Addendum Number: 1.0

Addendum Issue Date: February 22, 2024

Project Name: Clarinda Correctional Facility – Kitchen & Laundry

RFB Number: 922300-03

1 FOODSERVICE EQUIPMENT PLAN - AREA 2
1/4" = 1'-0"

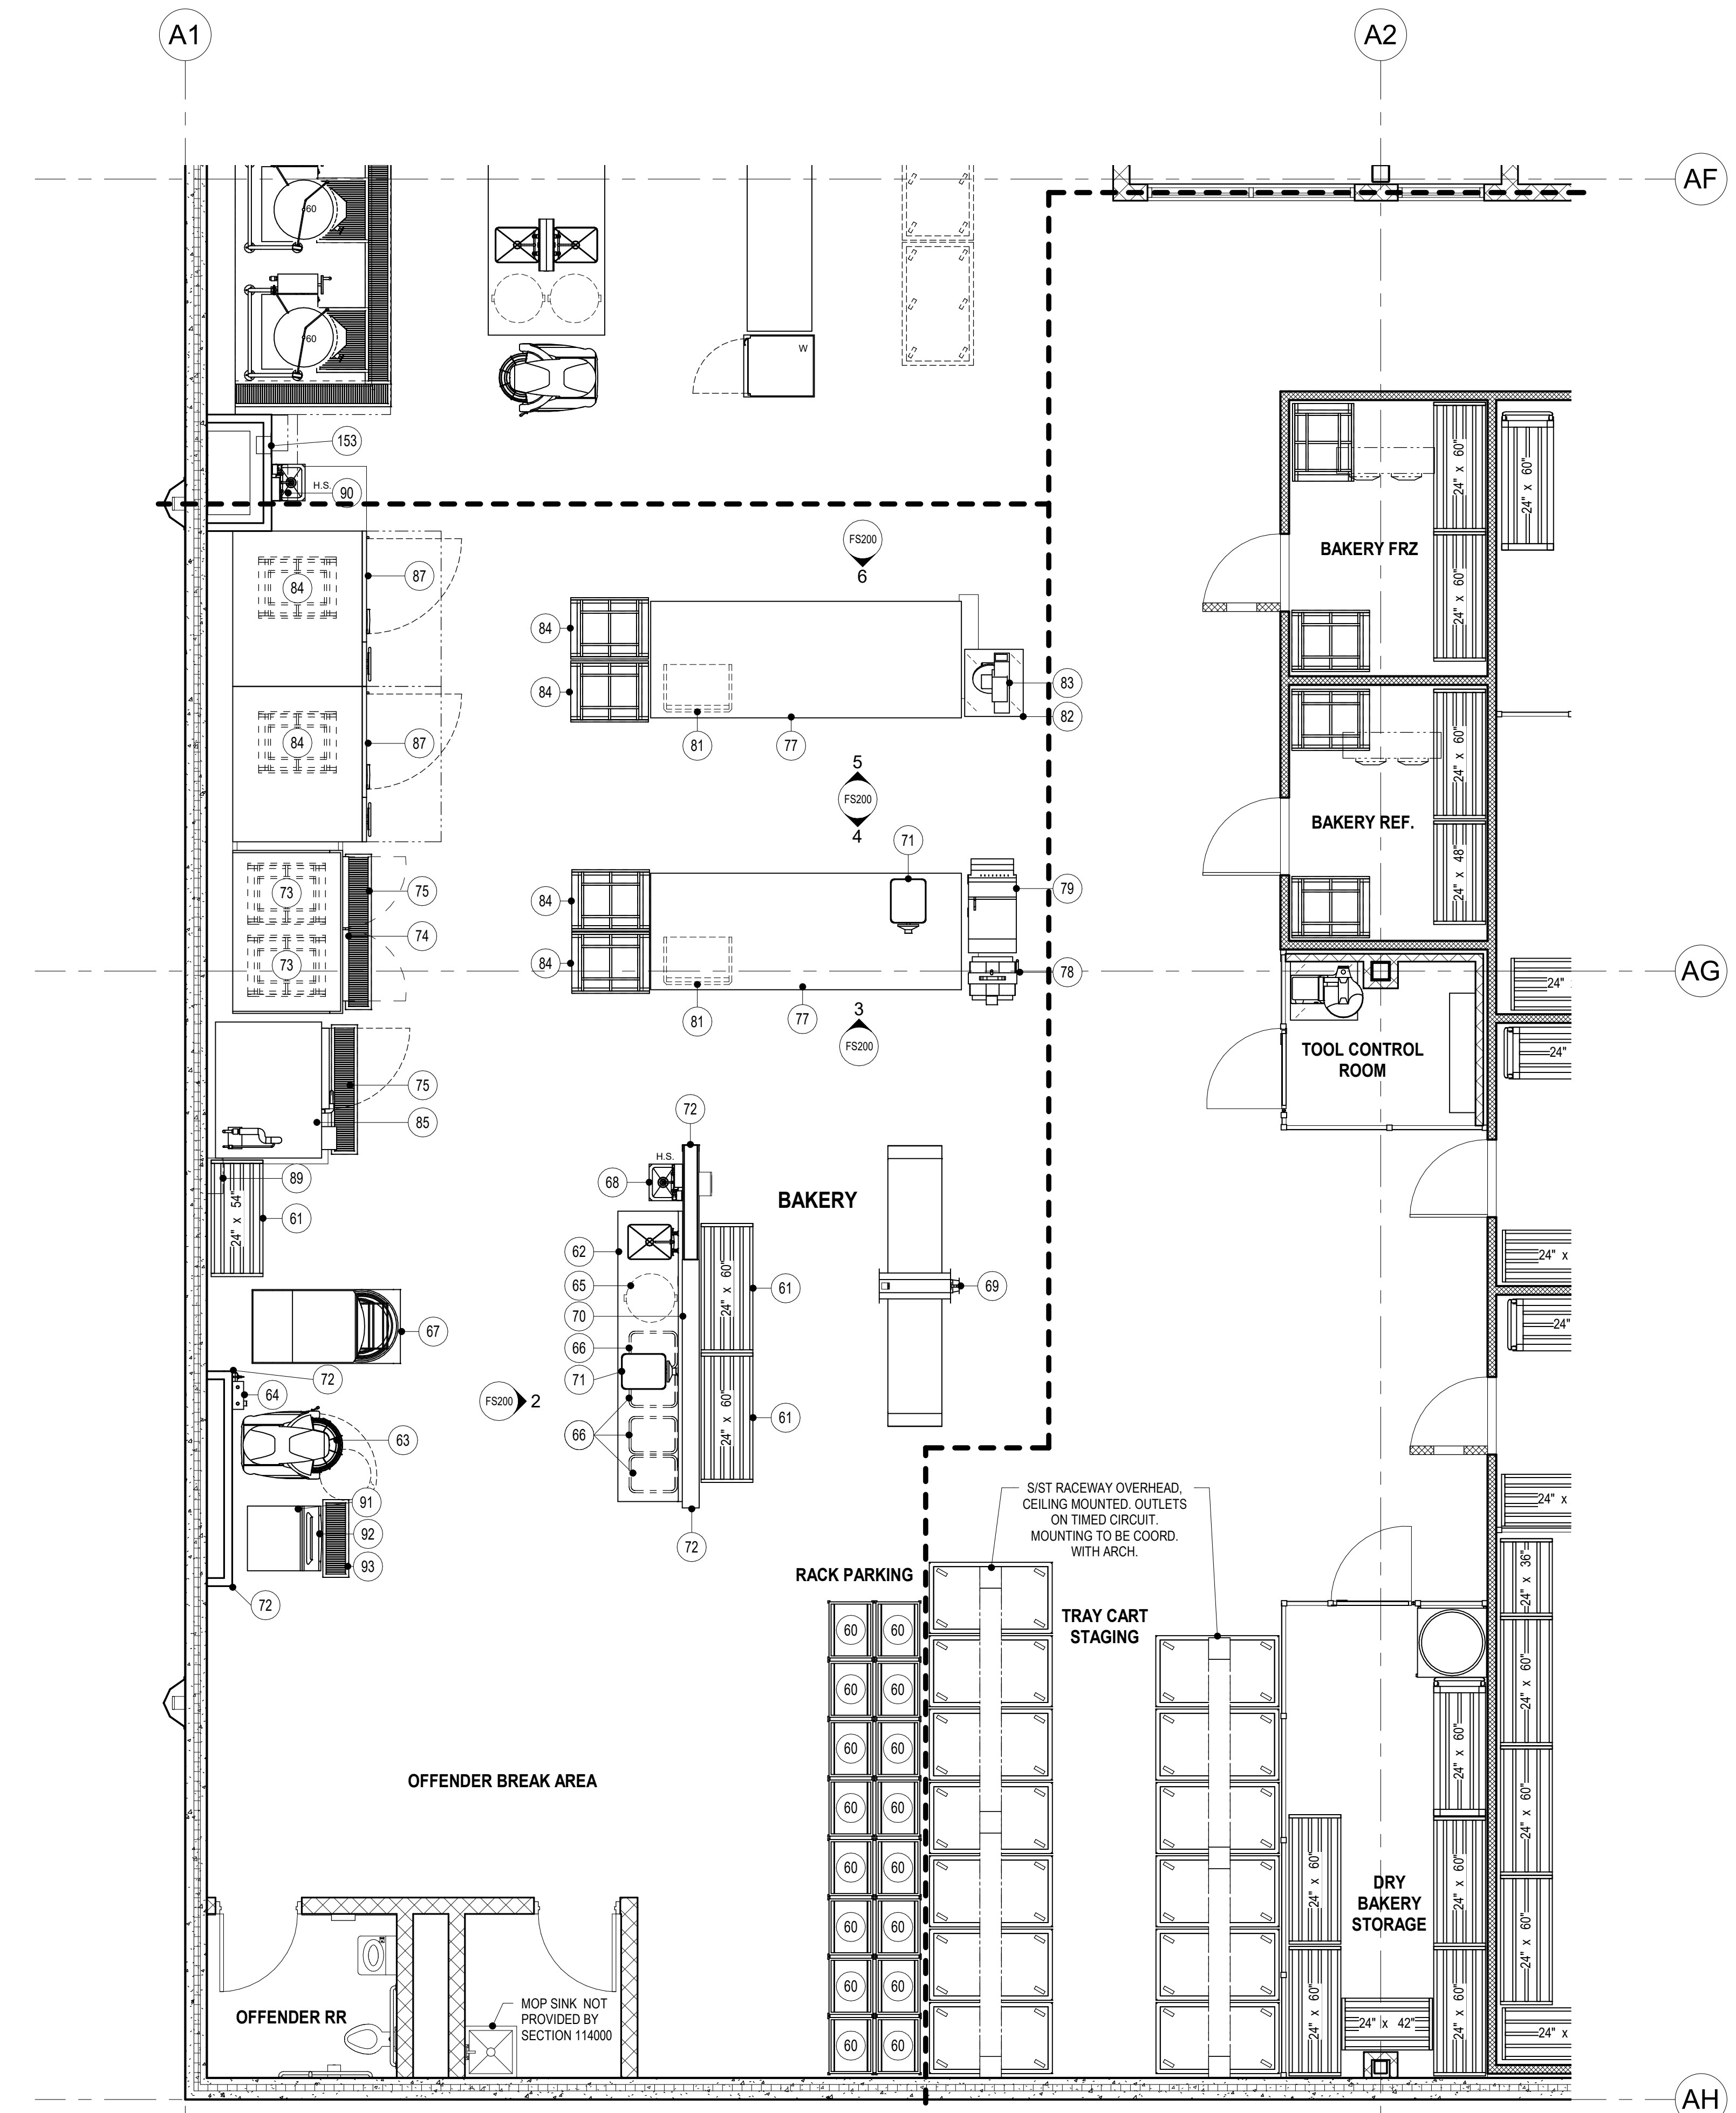
- Item No. 3. FS101 – FOODSERVICE EQUIPMENT PLAN AND SCHEDULE - AREA 1
Reference Foodservice Equipment Schedule – Area A
1. **REVISE** schedule as shown in updated attached sheet
- Item No. 4. FS102 – FOODSERVICE EQUIPMENT PLAN AND SCHEDULE - AREA 2
Reference Foodservice Equipment Schedule – Area B
1. **REVISE** schedule as shown in updated attached sheet
- Item No. 5. FS103 – FOODSERVICE EQUIPMENT PLAN AND SCHEDULE - AREA 3
Reference Foodservice Equipment Schedule – Area C
1. **REVISE** schedule as shown in updated attached sheet
- Item No. 6. FSE100 – FOODSERVICE EQUIPMENT ELECTRICAL SCHEDULE & DETAILS
Reference Foodservice Equipment Electrical Schedule
1. **REVISE** schedule as shown in updated attached sheet
- Item No. 7. FSM100 – FOODSERVICE EQUIPMENT MECHANICAL SCHEDULE
Reference Foodservice Equipment Mechanical Schedule
1. **REVISE** schedule as shown in updated attached sheet
